May 22, 2019

**Re: DEP HDD Re-Evaluation Report – Request for Additional Information
Old U.S. 220 16" Horizontal Directional Drill (S2-0109-16)
Permit No. E07-459
Blair Township, Blair County**

RE: Sunoco Pipeline, LP Pipeline Project - Mariner East II
Palmer Lane (Old Route 220) HDD Location S2-0109
PA-BL-0001.0031-RD-16
Hydrogeological Re-Evaluation Report for 16-inch Pipeline
Blair Township, Blair County, Pennsylvania
RETTEW Project No. 096302011

Sunoco Pipeline, L.P.
Old Route 220 HDD Location
Figure 2 - Geologic Map
 Blair Township, Blair County, PA
 Project No. 096302011

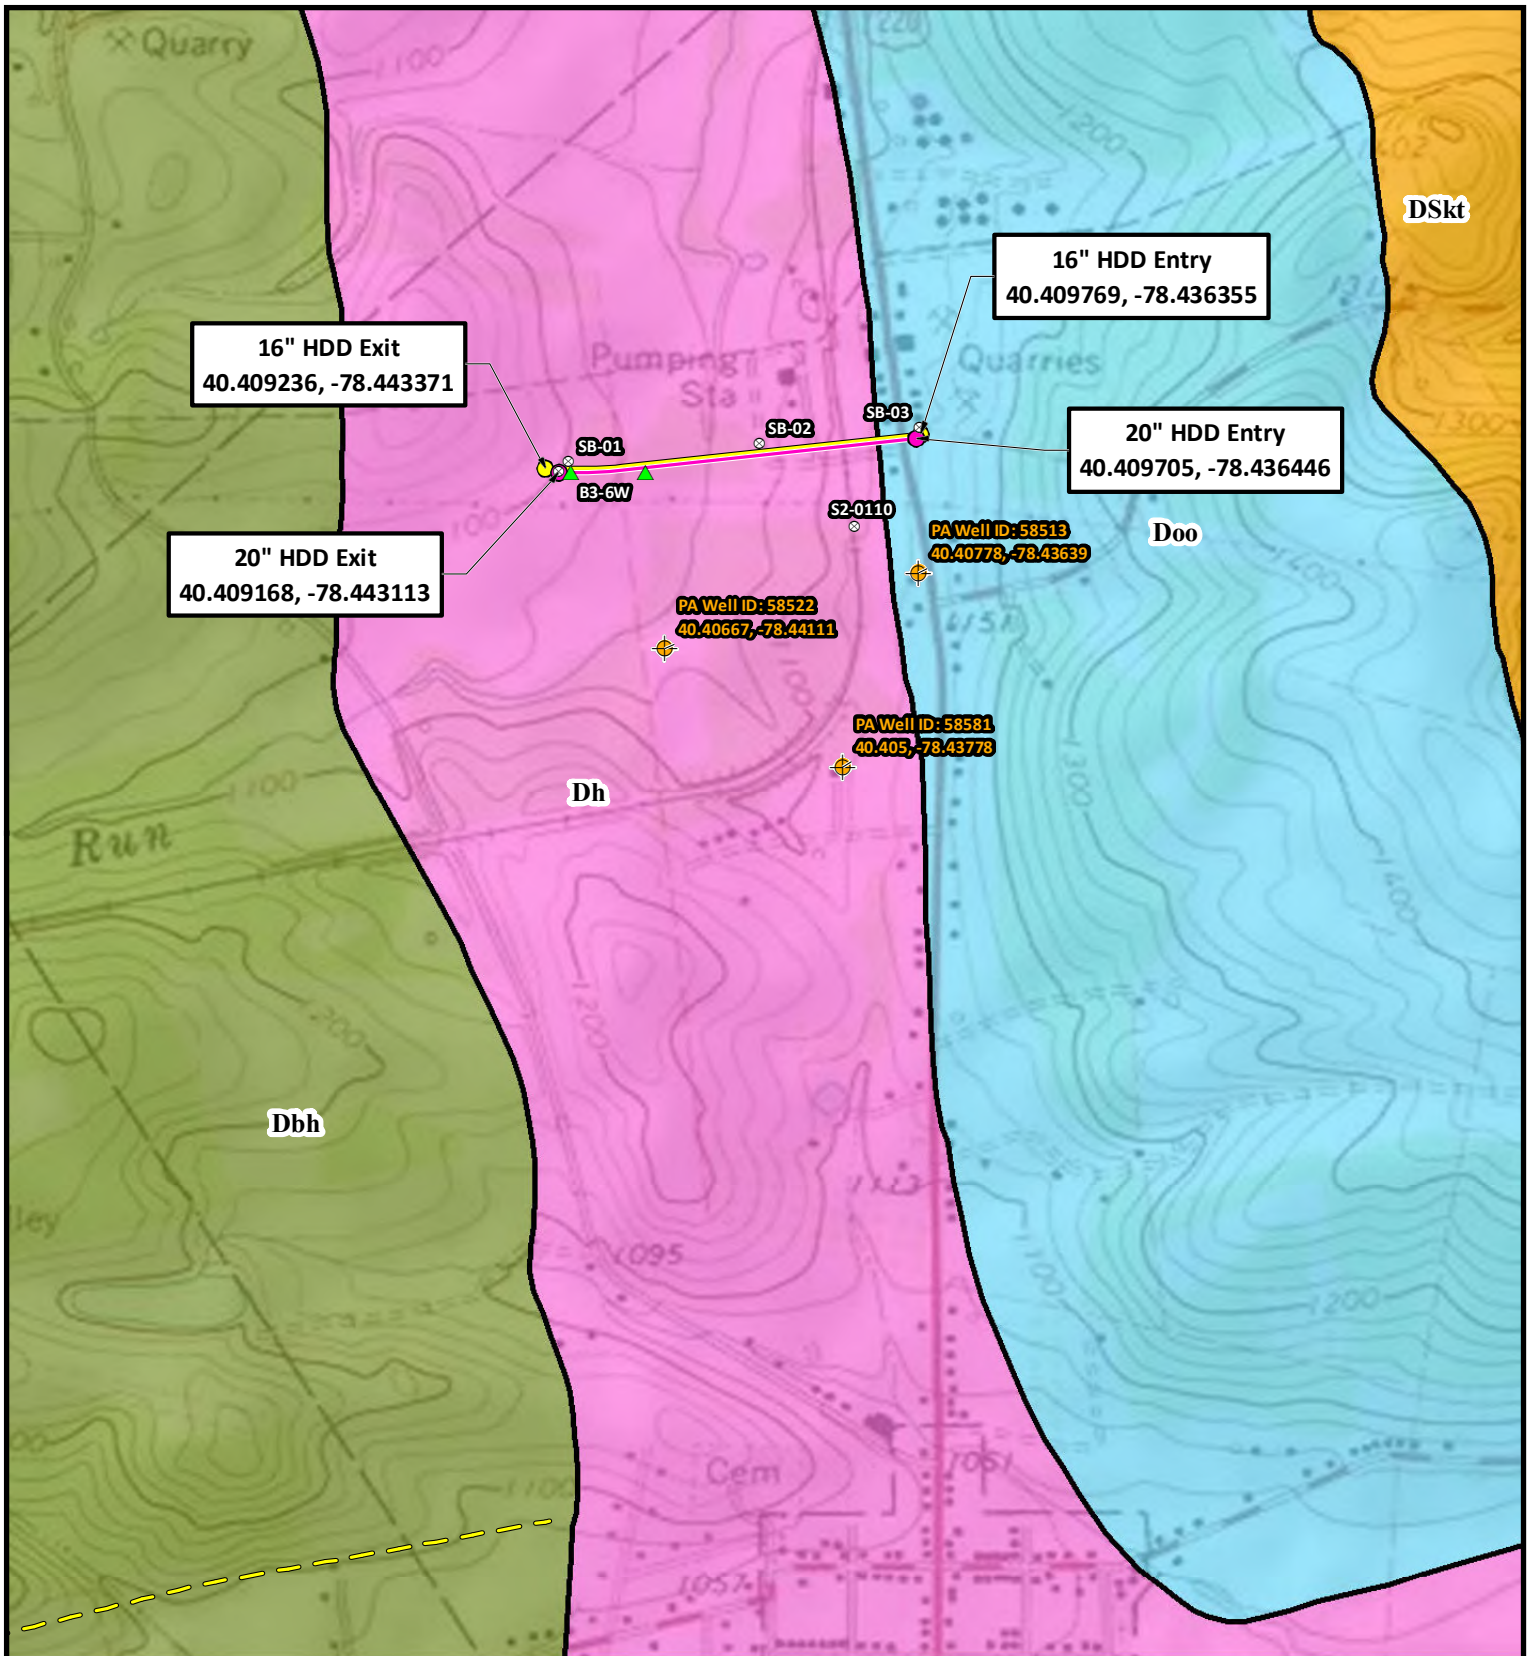
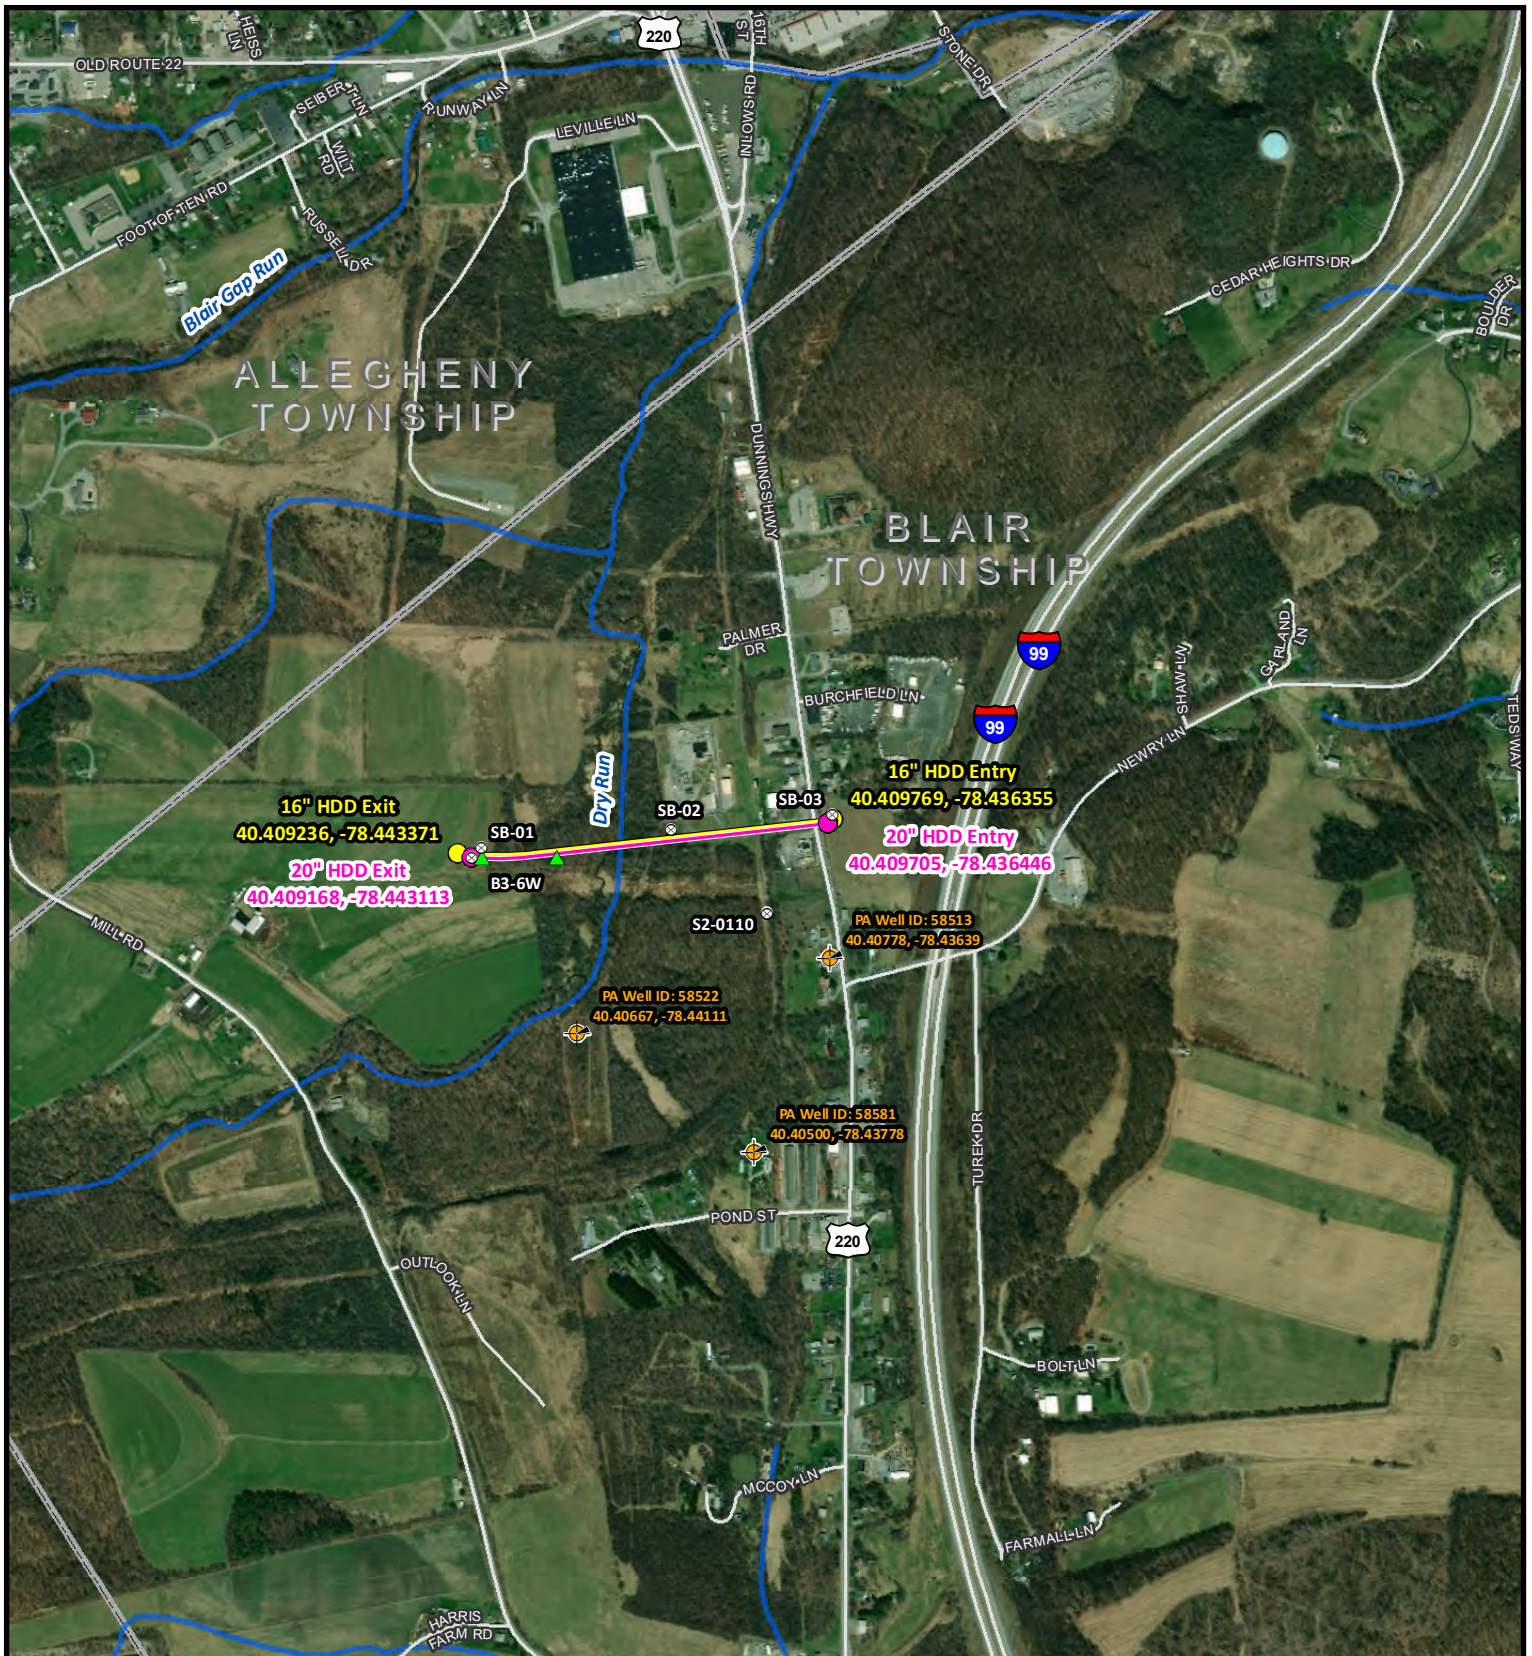
- b. The Geologic Report 4.0 Fracture Trace Analysis mentions eight fracture traces were identified and are shown on Figure 2 and 3 of the report. Figures 2 and 3 of the report only show one inferred fracture trace.**

The report has been revised and is included as an attachment.

Figures 2 and 3 show the results of the fracture trace analysis overlain on the geologic map of the site and an aerial base map. One fracture trace was identified within close proximity to the Palmer Lane HDD that is likely related to the primary geologic structure. The fracture trace trends approximately northeast-southwest (NE-SW), parallel to geologic strike.

PROFILE VIEW

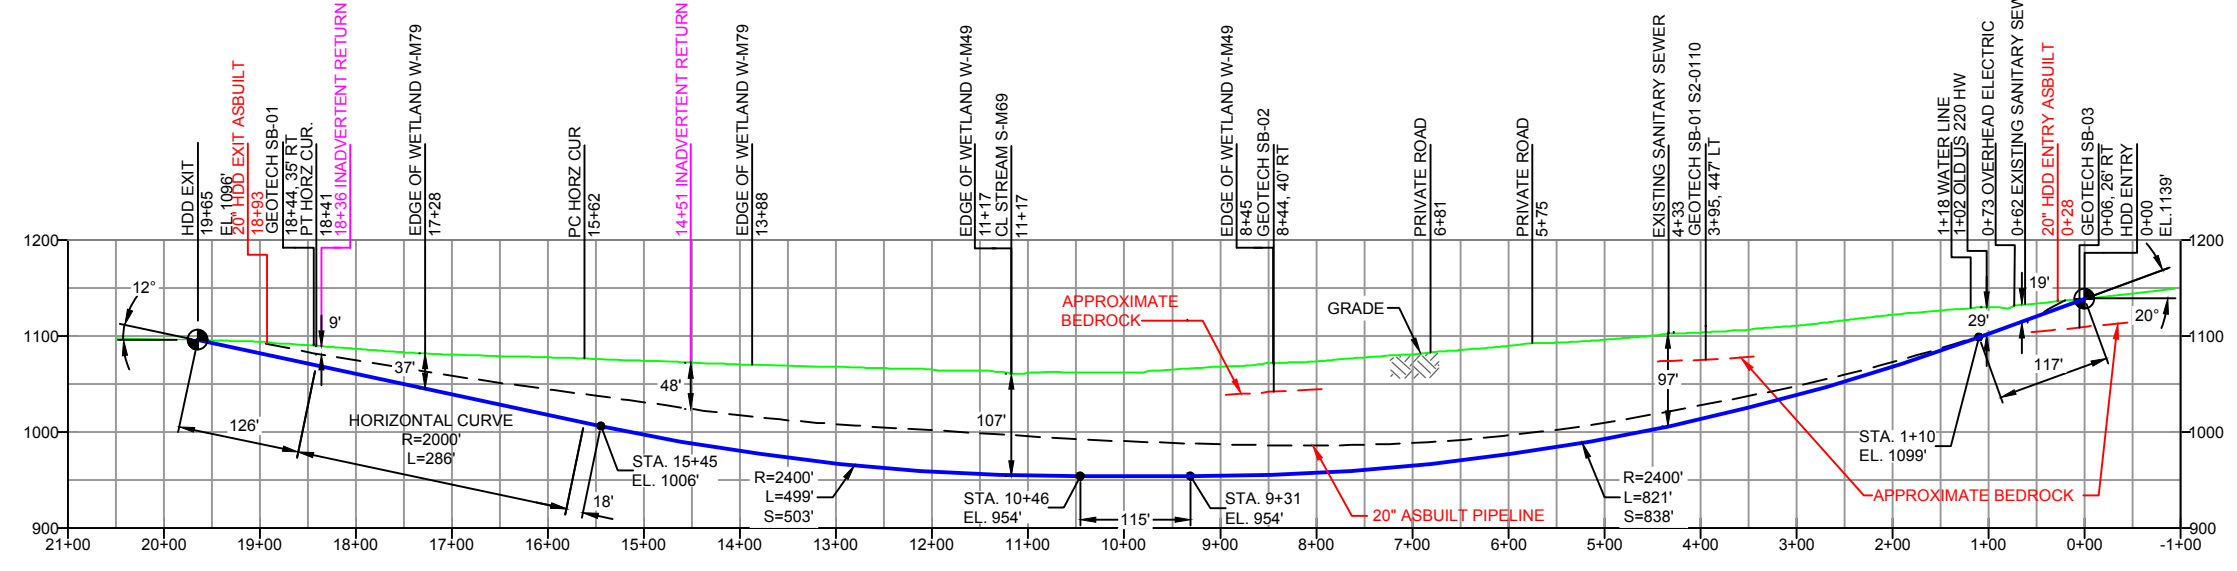
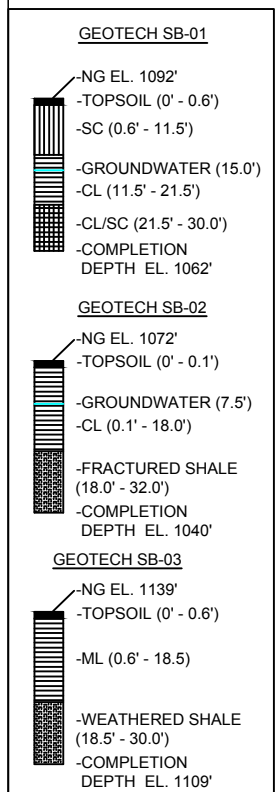
- a. There is no analysis in the re-evaluation report specifically tying the revised drill path to any specific zones noted on the core boring logs, or why the revised 16-inch path was chosen. Please provide a discussion addressing the use of this data in designing the bore path.**

The profile was redesigned to reduce the potential of IRs during the 16-inch HDD. The entry and exit angles of the 16-inch HDD profile have been increased to allow the drilling tools to advance through the unconsolidated soils and weathered bedrock into competent bedrock quicker and closer to the entry and exit points. The profile was adjusted such that in the event a “punch in/out” IR occurs, it is more likely occur in an upland area and within the limits of disturbance where it can be controlled quickly and contained by LOD perimeter controls. Secondly, the profile maximum depth has been increased by 32 ft to 111 ft below ground surface (bgs). This places more of the profile through bedrock with higher rock quality designation (RQD) values as identified in the 2017 geotechnical investigation. These design changes along with best management drilling practices will be used to reduce the risk of IRs from occurring during the completion of the 16-inch HDD.

Specifics relative to the redesigned 16-inch HDD profile include; (1) a 20-degree angle to the normal ground surface is set at the entry, which exceeds normal parameters and requires digging of a ramped surface for setting the drilling rig on, but this accelerates the entry into competent rock. Adversely, this also requires using custom-fabricated bends for connecting the drill pipeline segment to the standard open cut pipe; (2) the HDD exit point is chasing a rapidly increasing slope as proceeding west, which complicates the exit design. Paralleling a rising slope results in a linear extension of the profile in close proximity to the land surface which elevates the risk of an IR. Therefore, an additional buffer to the adjacent wetlands was added by relocating the exit further west, as limited by the increasing slope to minimize IR risk. The end result of the entry and exit points results in the required design of the profile tangents and horizontal design. There is only 115 ft of horizontal run, which is very limited in extent to make corrections in the profile when coming out of the entry 2,400 ft radius, to hit the 2,000 ft exiting radius.

SPLP reviewed the daily drilling reports, previously completed geotechnical investigations, and HDD Inspection Daily Reports for each event that resulted in an IR. The results of the geotechnical investigation were used in determining the root cause(s) of the three IRs reported during the completion of the 20-inch HDD. Further, the depth of the pilot tool/reamer was compared to the geotechnical investigation to determine if the pilot bit was advancing through unconsolidated material or highly weathered and fractured bedrock. This information was then utilized to redesign the 16-inch profile resulting in an increase in the entry and exit angles and the overall depth of the profile. These modifications were made to minimize the distance the profile would be completed in unconsolidated material or highly weathered or fractured bedrock. Once in bedrock, the profile was designed to be advanced through good quality bedrock (i.e., RQD values greater than 50).
